**TOWN OF NEWBURGH
PLANNING BOARD
TECHNICAL REVIEW COMMENTS**

PROJECT NAME: GAS LAND PETROLEUM, INC.
PROJECT NO.: 2019-16
PROJECT LOCATION: 5200 ROUTE 9W
SECTION 43, BLOCK 5, LOT 1
REVIEW DATE: 13 SEPTEMBER 2024
MEETING DATE: 19 SEPTEMBER 2024
PROJECT REPRESENTATIVE: LABELLA

1 DEMOLITION PLAN
SCALE: 1"=20'

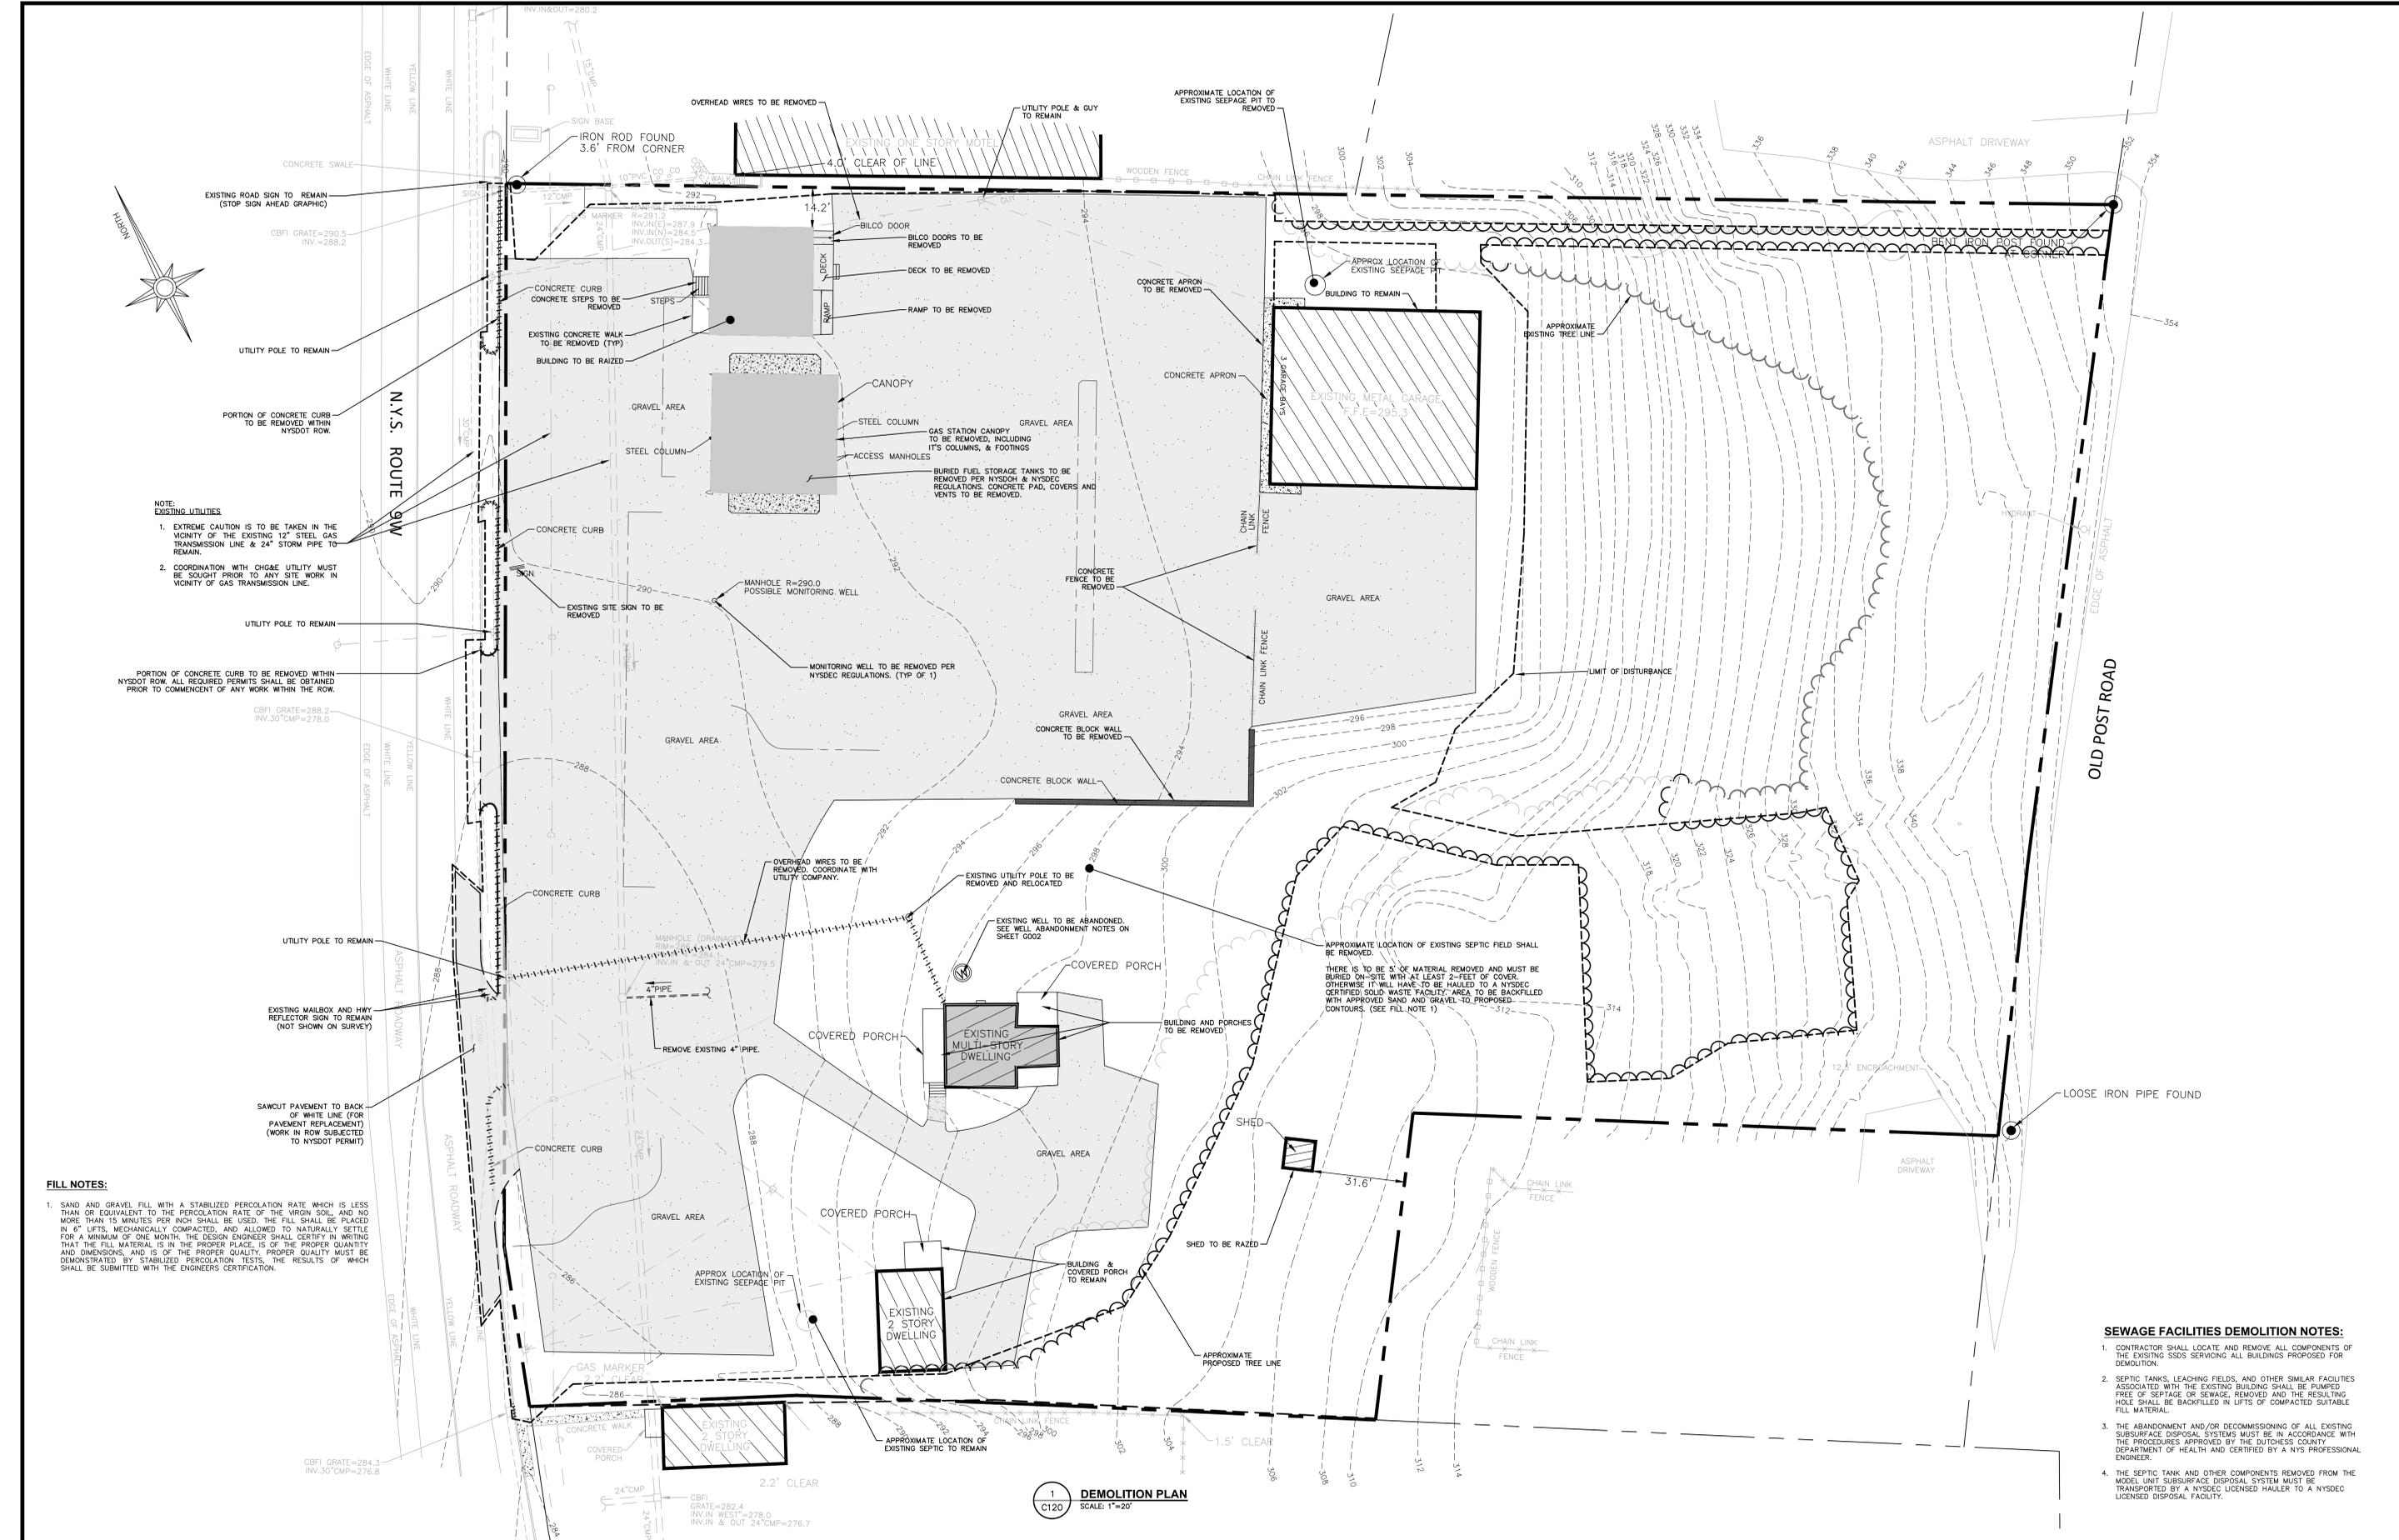
7. A note appears on the plan identifying potential underground tanks, potential contaminated soil and previous piping. Status of any underground tanks should be identified and addressed on the plans.

8. A permit from the Town of Newburgh is required for any tank removals.
9. Coordination with Central Hudson Gas and Electric should be undertaken regarding proposed activities within the Central Hudson gas line easement. Several proposed utilities including stormwater, potable water as well as the site access drive improvements cross the Central Hudson high pressure gas main.

1 UTILITY PLAN
SCALE: 1"=20'

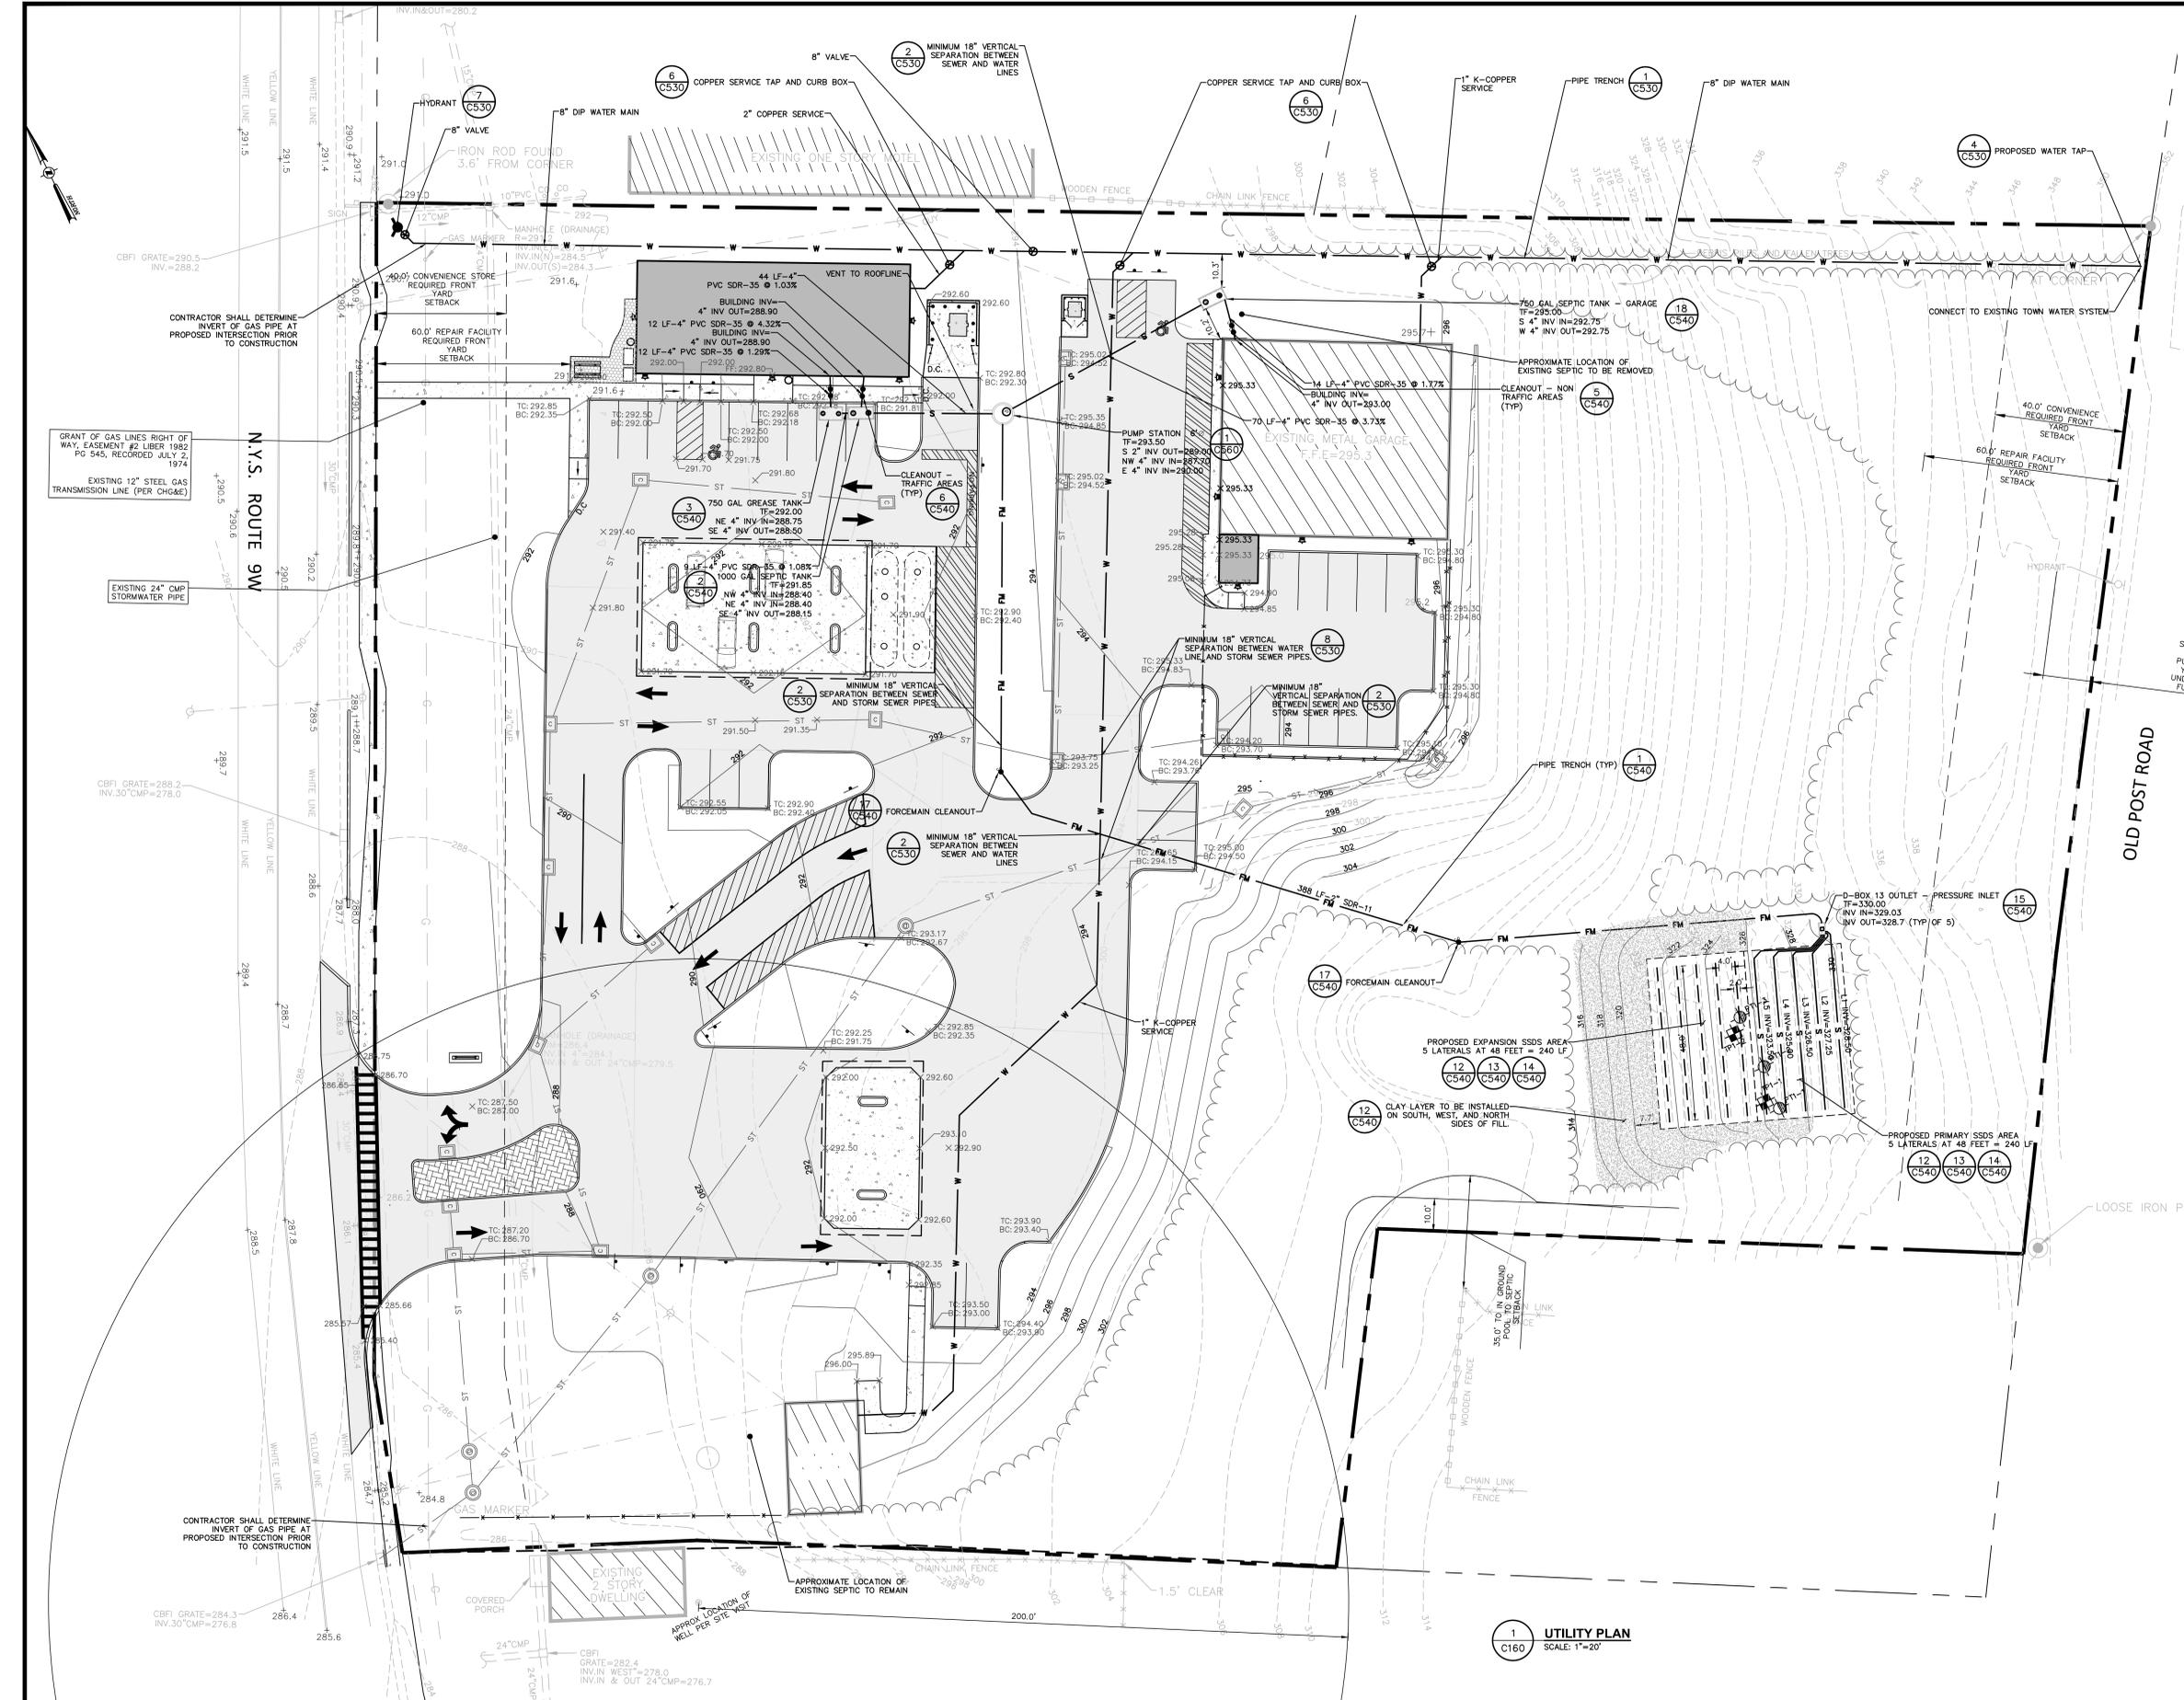
1. The subsurface sanitary sewer disposal system has been revised according to our previous comments. Surface sanitary sewer disposal system is now located in an area without proposed filling. The system is designed to treat 356 gallons per day based on the SSDS Demand Calculations provided.

4. A watermain has been depicted on the plans which has been up-sized to 8 inches. An easement in favor of the Town of Newburgh is proposed. Any approval should address the easement for the watermain.

14. A location on the plan where the former subsurface sanitary disposal system material is to be buried should be depicted.
15. Information pertaining to the existing 2-story dwellings subsurface sanitary sewer disposal system should be provided.
